Z-56
(2017)

PROVIDENCE ESTATES
REZONING PLAN

LAND LOTS 26, 27, 46 & 47
16TH DISTRICT, 2ND SECTION
COBB COUNTY, GEORGIA
JUNE 13, 2018

PETITION NO.: Z-56

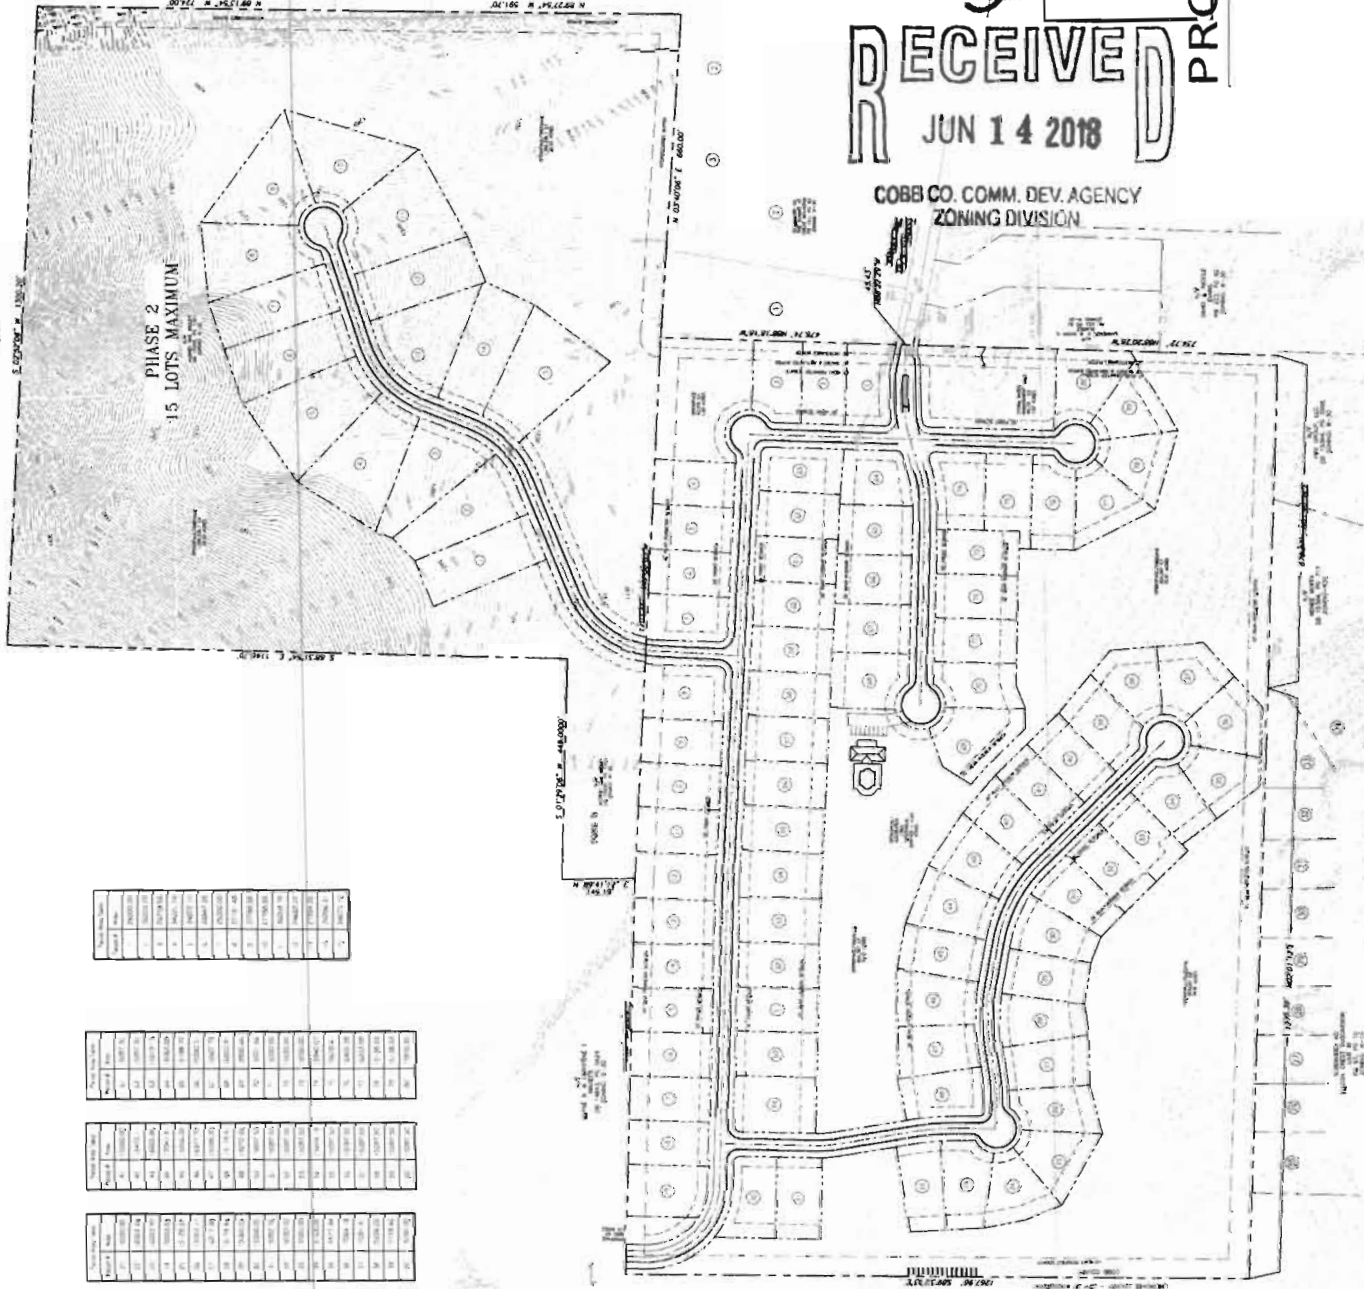
- 1.) Impervious surfaces of amenity areas should be subtracted from the total area to determine Net Buildable Area. Please provide acreage of the impervious surface of amenity area on site plan. Also, please note on plan that no floodplains, wetlands and/or cemeteries are evident on site, if that is indeed the case.

- 2.) Revised April 17, 2018 Stip. Letter to be consistent with revised Site Plan dated June 13, 2018. Item #1 depicts 45% of the site will be open space. The June 13, 2018 revised plan shows 51% when accounting for .26 acres of Amenity Area.

- 3.) Slopes greater than 25 percent must be included in the required open space, but shall allow for perpendicular (except when non-perpendicular is necessary to satisfy drainage/storm water requirements) utility and access crossings, when necessary. Based on GIS generated slope analysis, there are several lots that encroach into slopes greater than 25%.

- 4.) The buffer area on the southern and eastern portions of the subject property show 40 foot. Item #2 of the April 17, 2017 Stipulation letter says 50 foot. Please show 50' undisturbed buffer along the

southern and eastern portions of the subject property, as well as to the rear of lots 42 and 43 on the western side of subject property.

- 5.) Either on the plan or in stipulation letter include language referencing fencing that is compatible with the architecture/landscape/design of development shall be established along lot lines that are contiguous to open space.
- 6.) A Conservation Easement must be recorded in the mandatory subdivision covenants and with Cobb Superior Court, thereby protecting the “Open Space” from development in perpetuity as owned by the mandatory Home Owners Association. Conservation Easement application must be submitted to the Planning Division before final plat approval.

2. Although there are two parcels identified on the site plan as reserved for stormwater management, it is likely that a third onsite detention pond will be required to adequately control runoff from the development to the west. This pond would most likely be located to the rear of Lot 25.

The parcel to the northeast of the site has current access on Wigley Road. The current site plan shows this access removed. Recommend providing public access to this parcel from the newly aligned roadway.
